|  HYUNDAI Technical Service Bulletin | GROUP AUTOMATIC TRANSMISSION | NUMBER 19-AT-003H-1 |
| | DATE MAY, 2019 | MODEL(S) SONATA (YFa) |
| SUBJECT: | AUTOMATIC TRANSMISSION 2-3 SHIFT FLARE | |

This TSB supersedes TSB 19-AT-003H to revise the Parts Information.

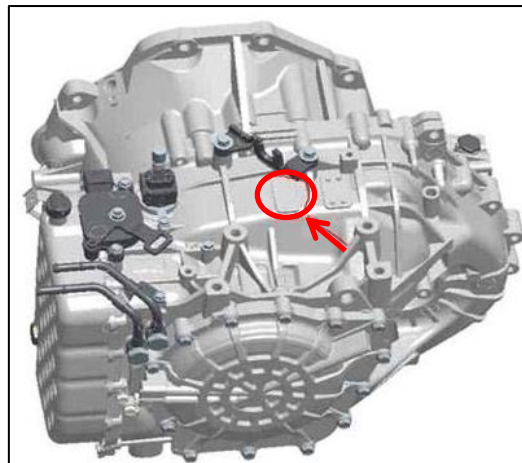
Locate the 12 digit Serial Code of the removed transmission at the location shown in the image.

1. Remove the air filter box and locate the Serial Code on top of the transmission. Refer to the Parts Information to determine the correct transmission.

Refer to Parts Information to confirm the installed transmission was the correct part number according to the first 4 digits of the serial code. If the installed transmission was:

- Incorrect ATM, install the correct ATM.
- Correct ATM, replace the ECU according to the Parts Information below.
